JV10-NL Block Diagram

Project code: 91.4HX01.001
PCB P/N : 48.4HX01.0SB
REVISION : SB

Title: **Modify History**

Date: Sunday, January 31, 2010 Sheet 42 of 42

Sheet 3 of 42

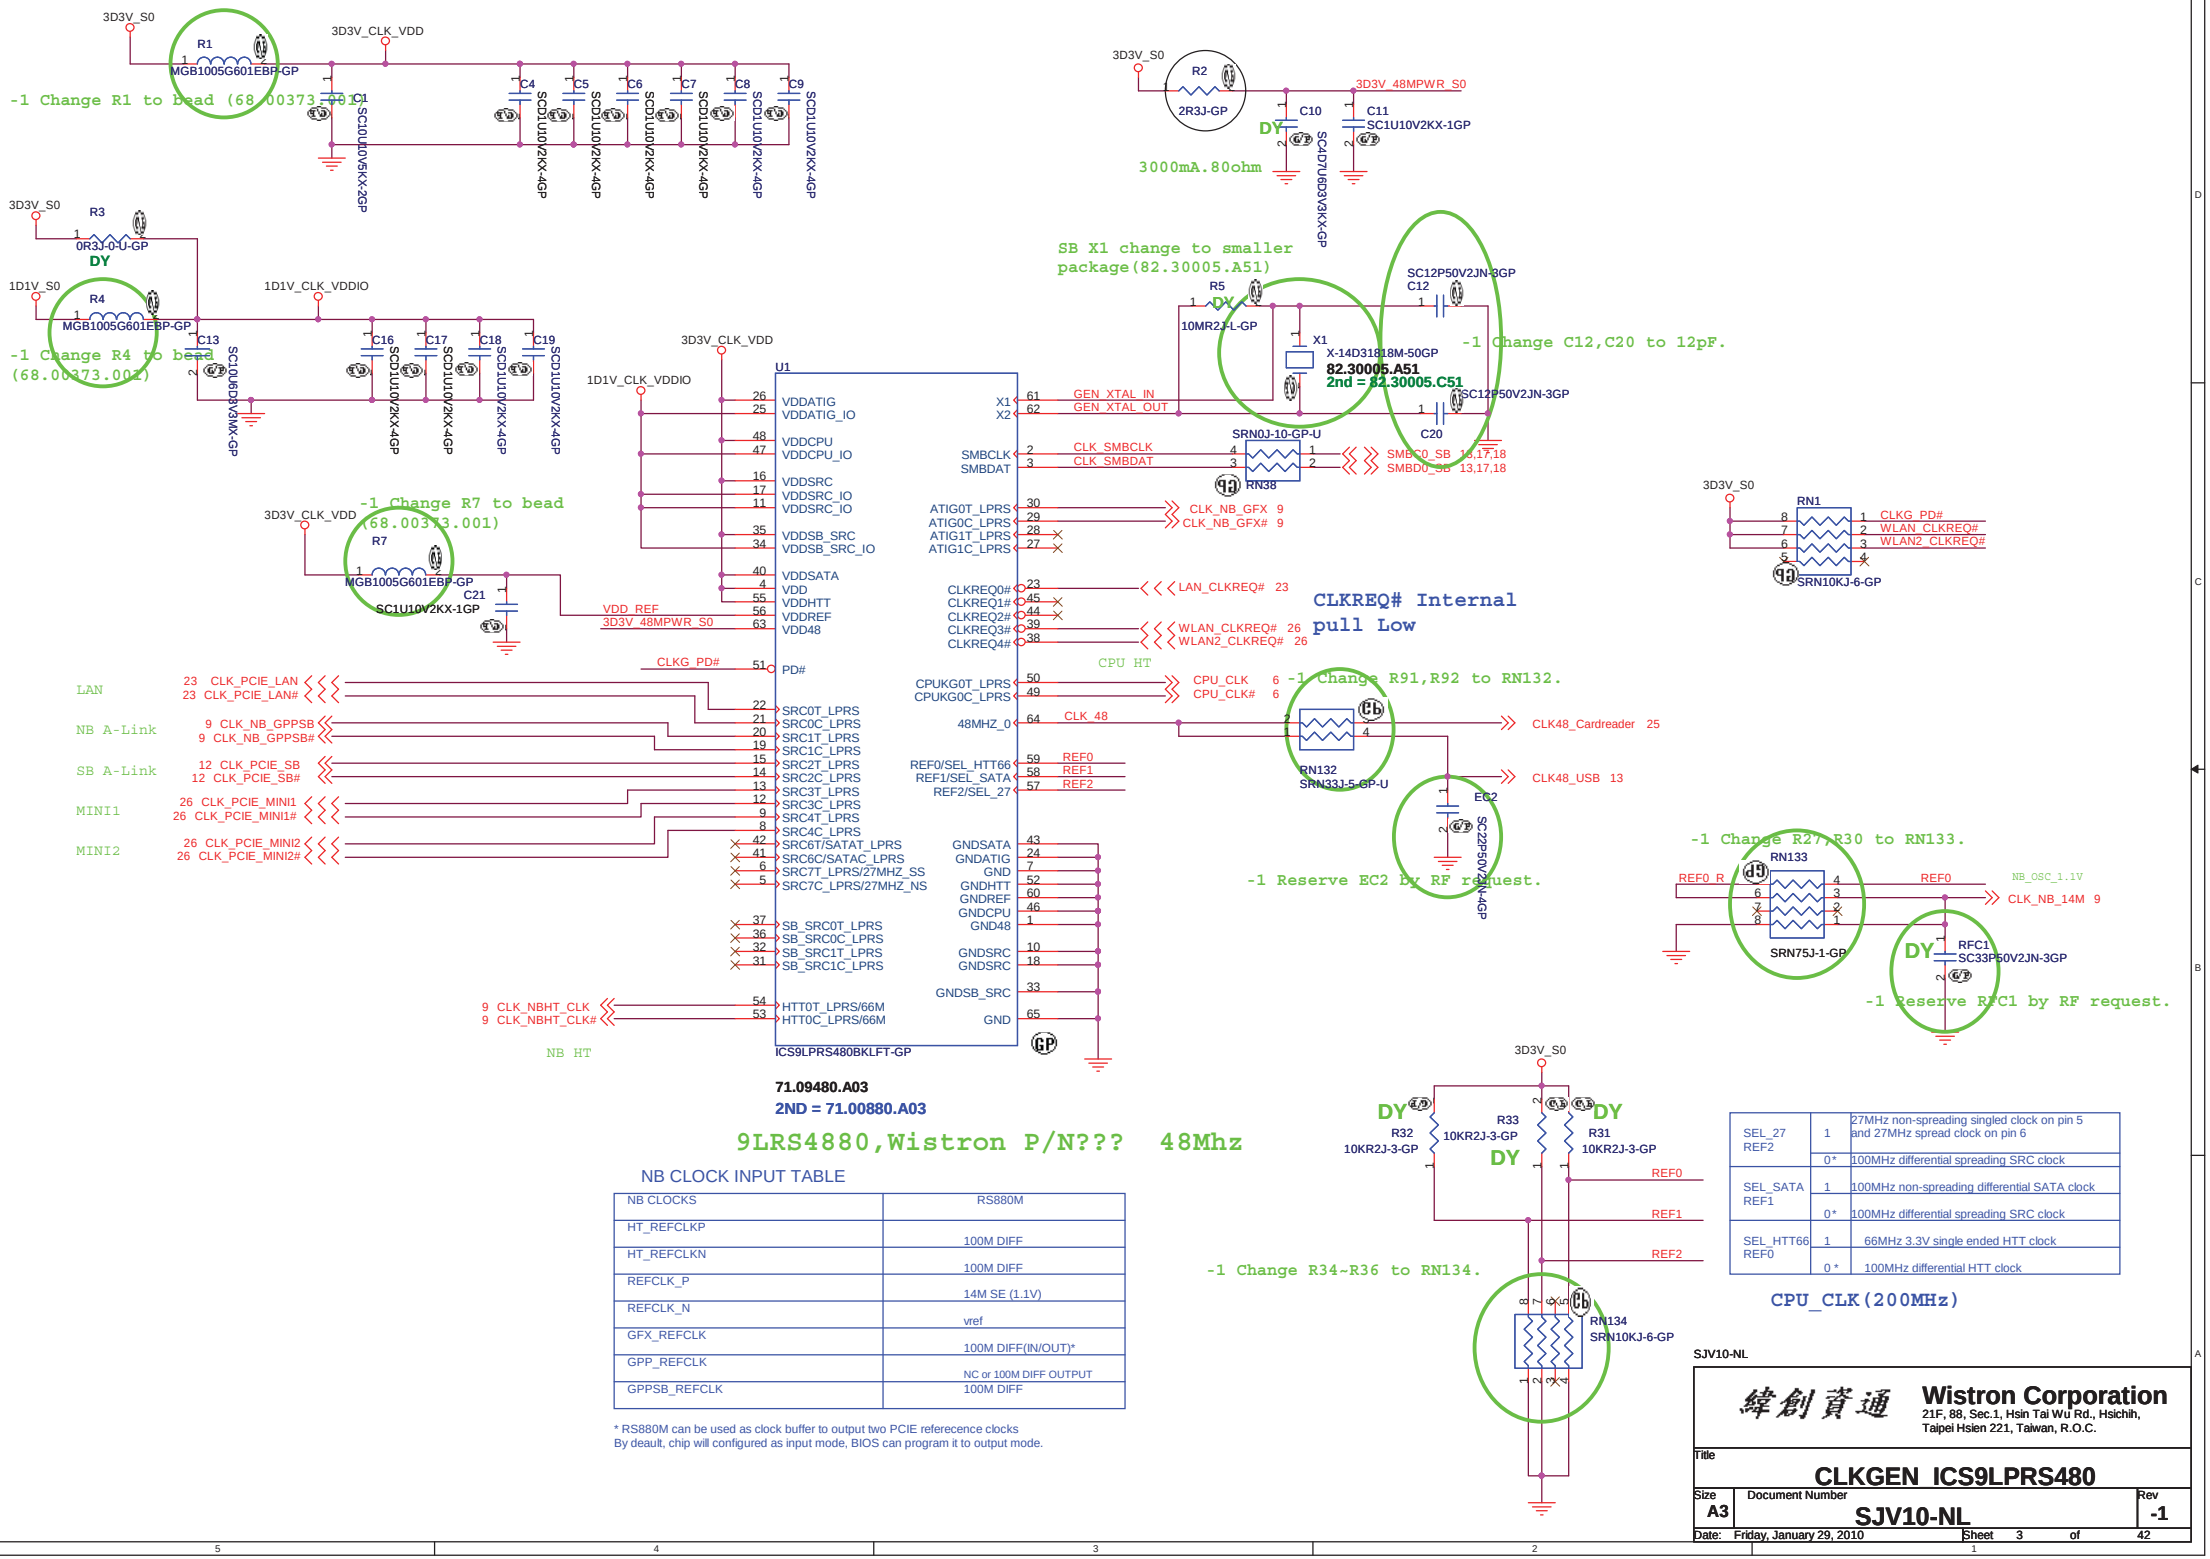
-1 Change R1 to bead (68.00373.001)
-1 Change R4 to bead (68.00373.002)
-1 Change R7 to bead (68.00373.001)
SB X1 change to smaller package(82.30005.A51)
-1 Change C12,C20 to 12pF.

82.30005.A51
2nd = 82.30005.C51
CLKREQ# Internal pull Low
-1 Change R91,R92 to RN132.
-1 Reserve EC2 by RF request.
-1 Change R27,R30 to RN133.
-1 Reserve RFC1 by RF request.
-1 Change R34~R36 to RN134.
CPU_CLK(200MHz)

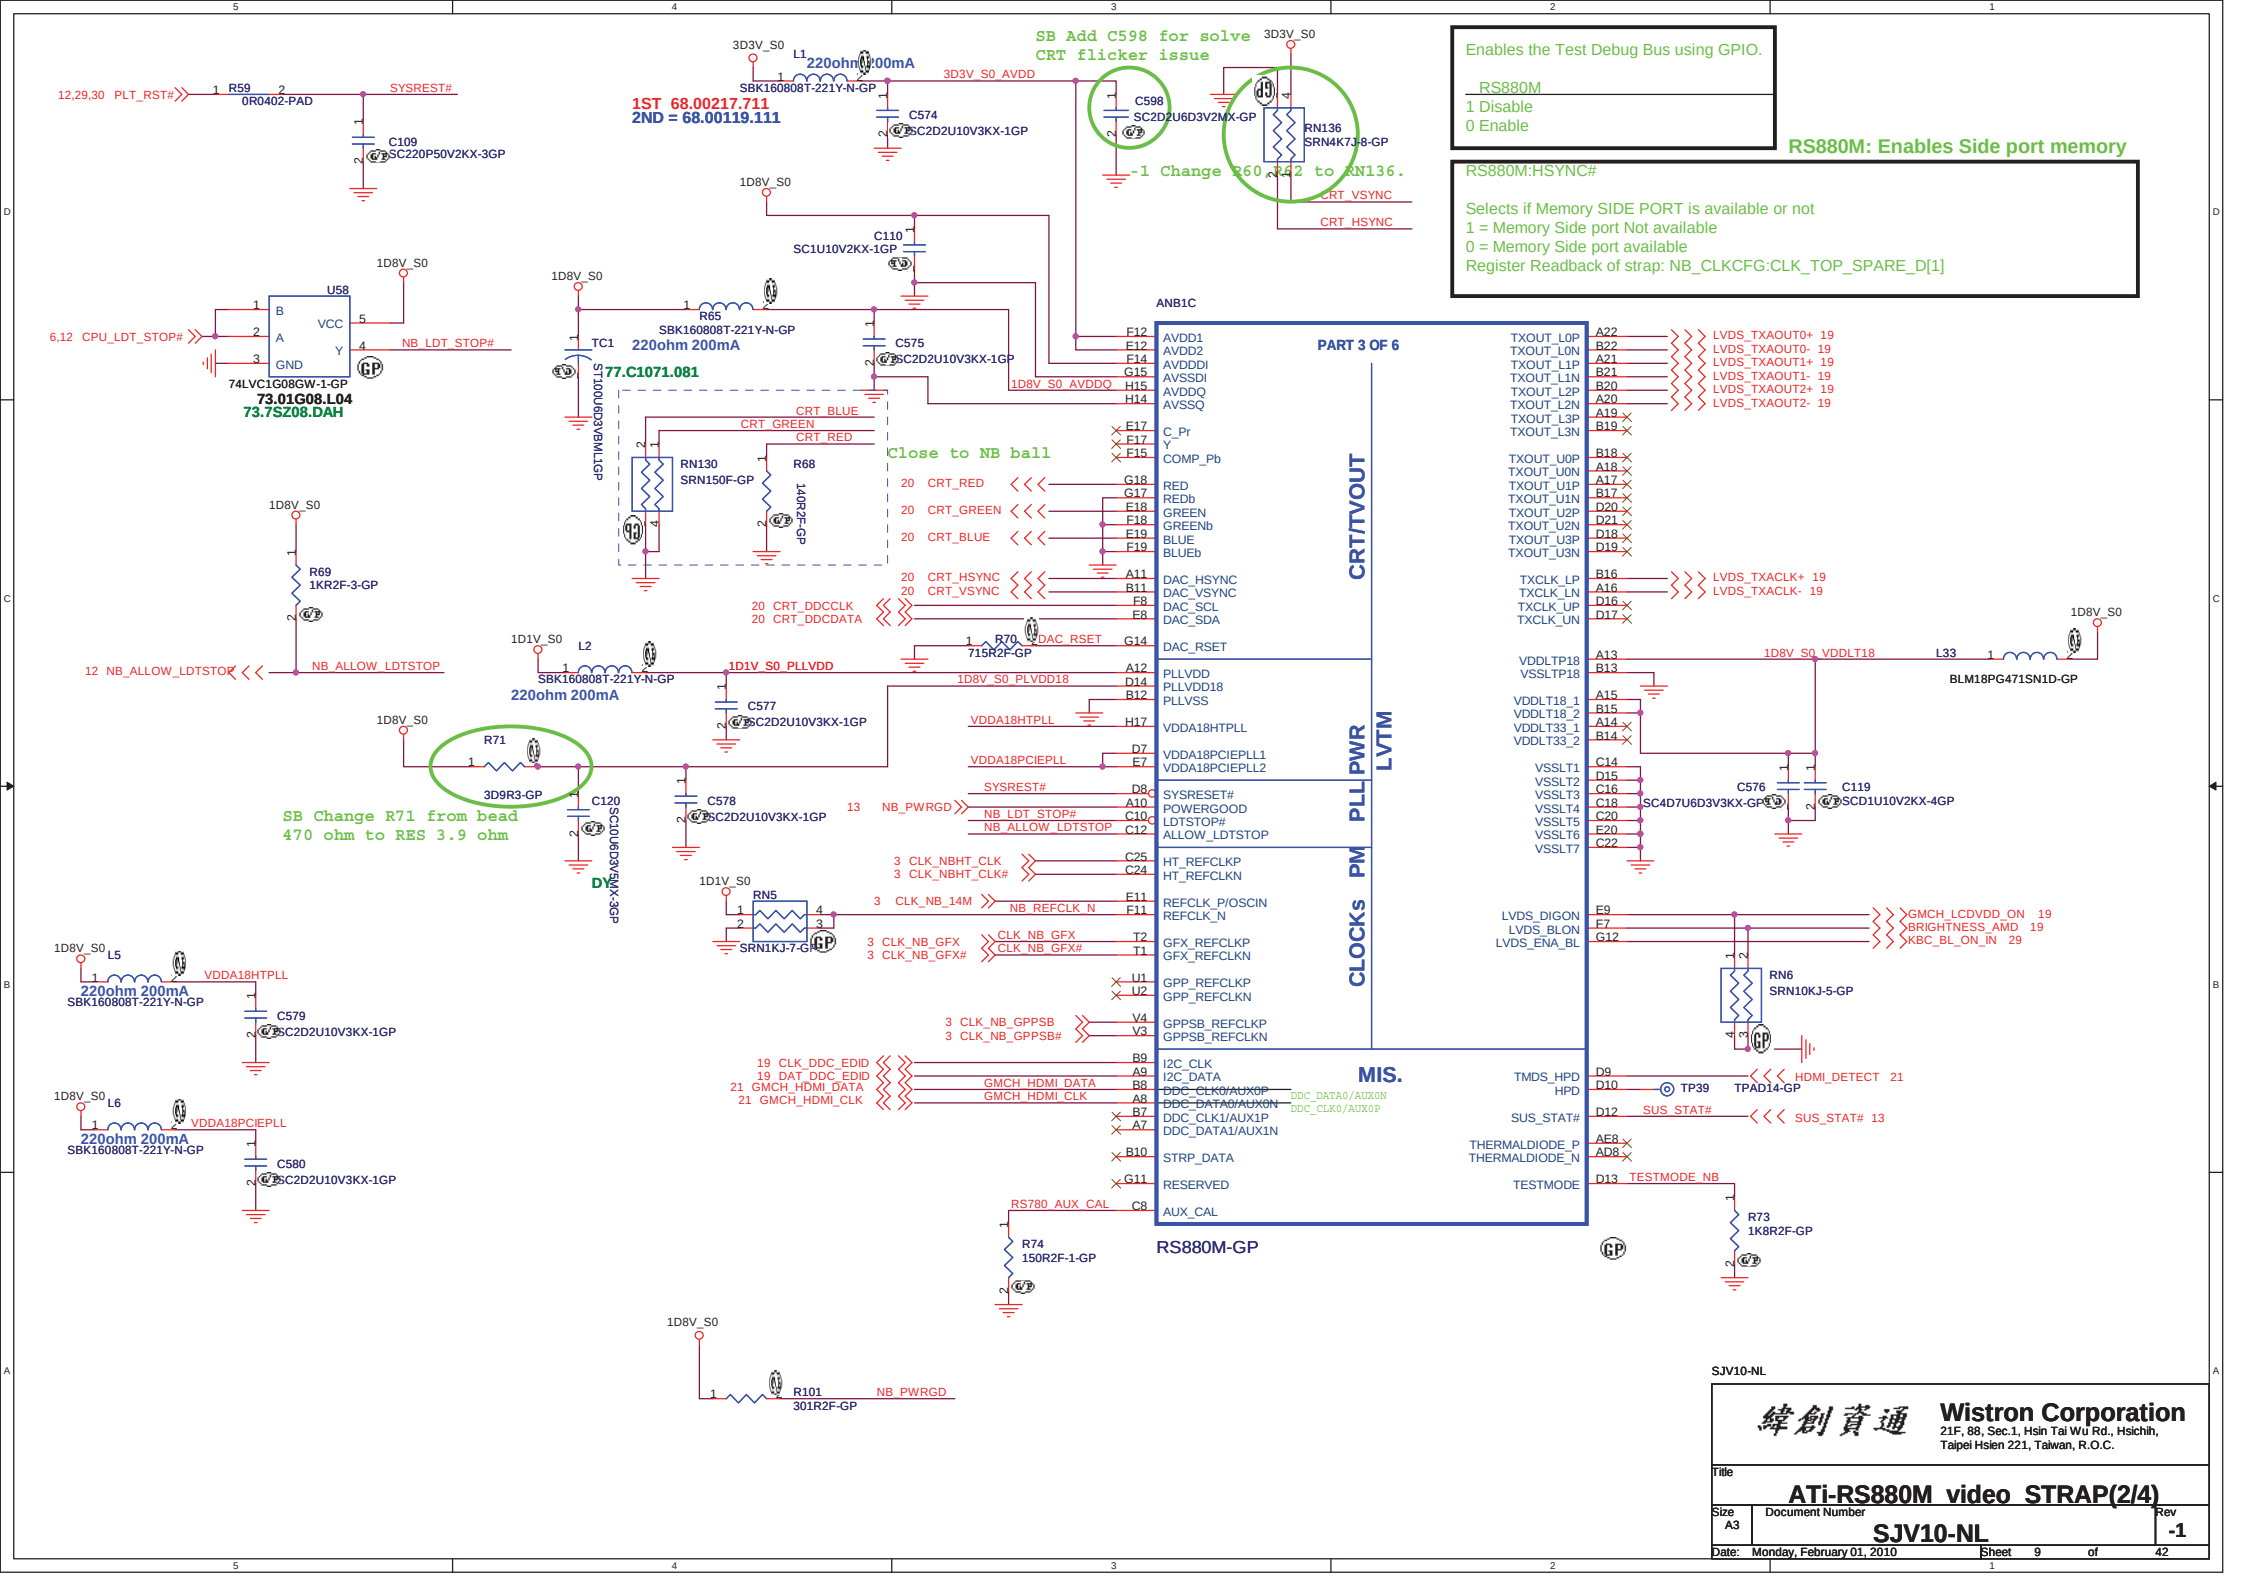
SB Add C598 for solve CRT flicker issue
Enables the Test Debug Bus using GPIO.
RS880M
1 Disable
0 Enable
RS880M: Enables Side port memory
RS880M:HSYNC#
Selects if Memory SIDE PORT is available or not
1 = Memory Side port Not available
0 = Memory Side port available
Register Readback of strap: NB_CLKCFG:CLK_TOP_SPARE_D[1]
1ST 68.00217.711
2ND = 68.00119.111
-1 Change R60,R62 to RN136.
Close to NB ball
SB Change R71 from bead 470 ohm to RES 3.9 ohm
ANB1C
PART 3 OF 6
CRT/TVOUT
PLL PWR LVTM
CLOCKs PM
MIS.
RS880M-GP
SJV10-NL
Wistron Corporation
21F, 88, Sec.1, Hsin Tai Wu Rd., Hsichih, Taipei Hsien 221, Taiwan, R.O.C.
ATi-RS880M video STRAP(2/4)
SJV10-NL
Rev -1
Date: Monday, February 01, 2010
Sheet 9 of 42

Date: Wednesday, January 27, 2010 | Sheet 10 of 42

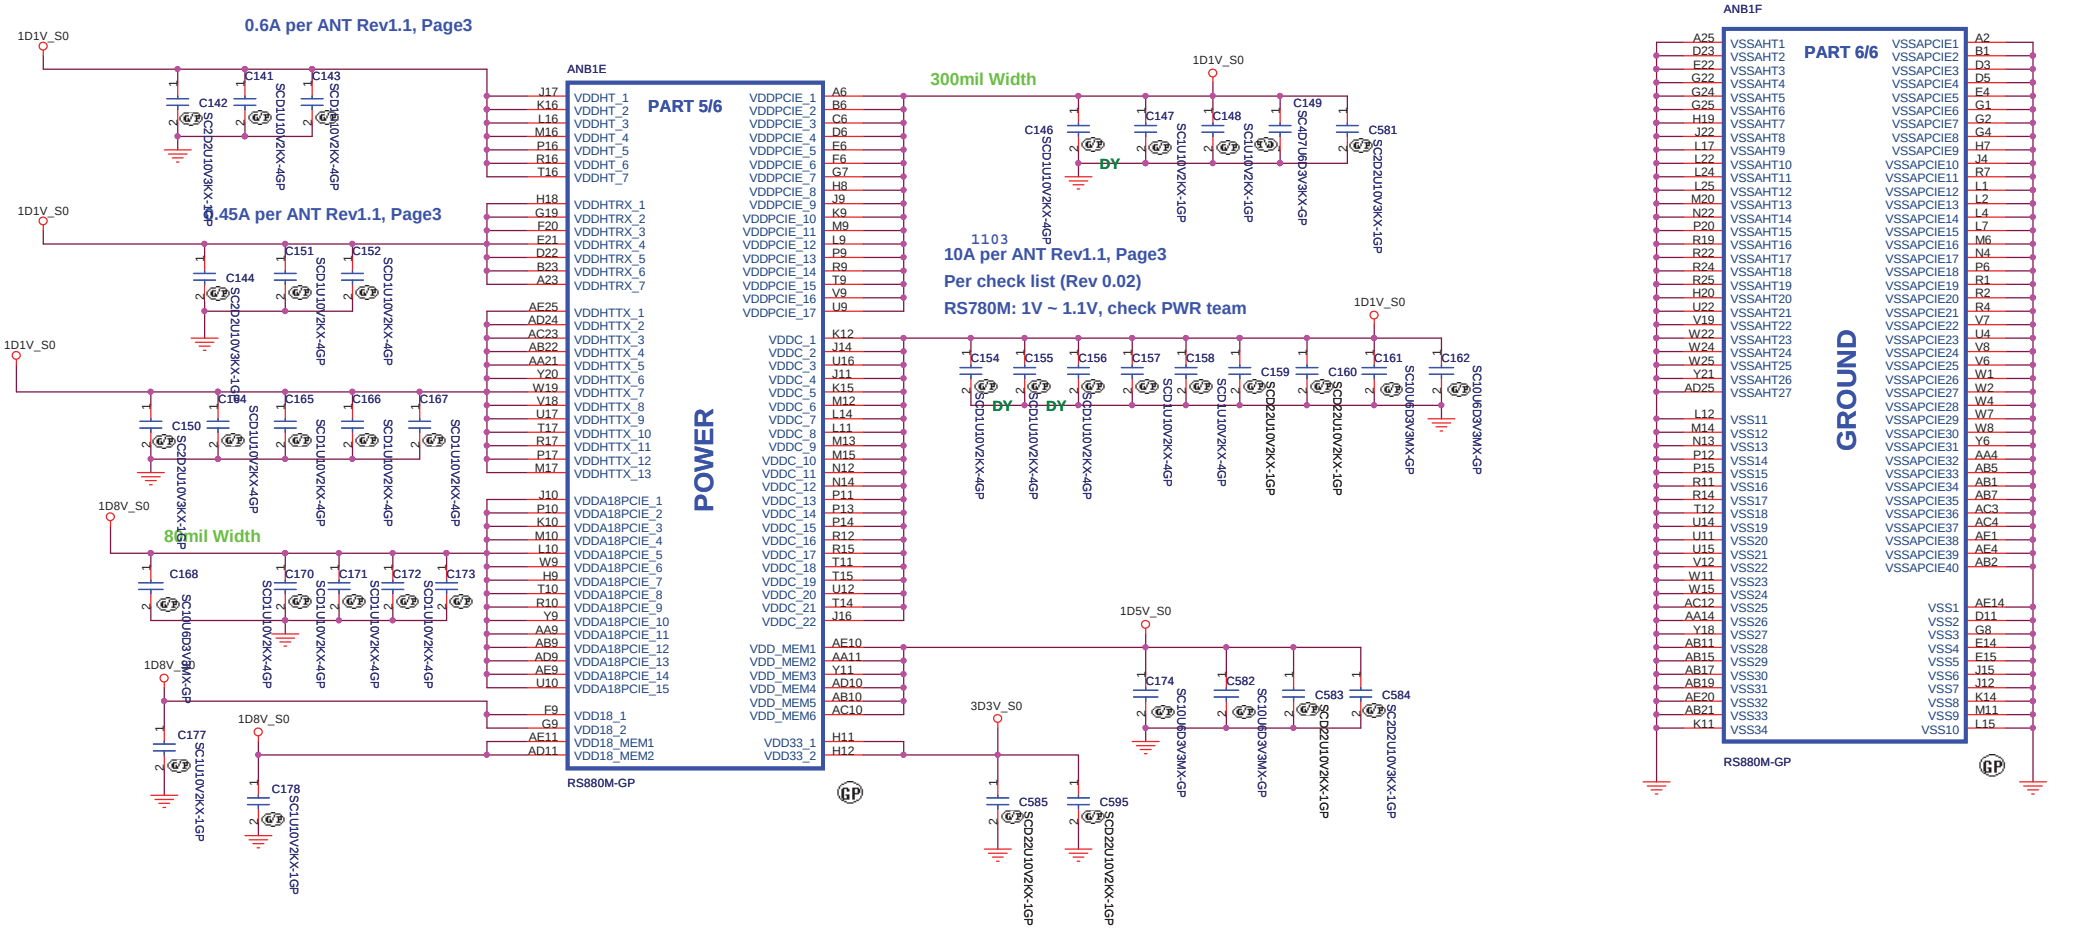
-1 Change R76,R78 to RN138. -1 Change R77,R79 to RN139.

-1 Change R84,R85 to RN137.

-1 DY F139 Change C140 to 22uF.
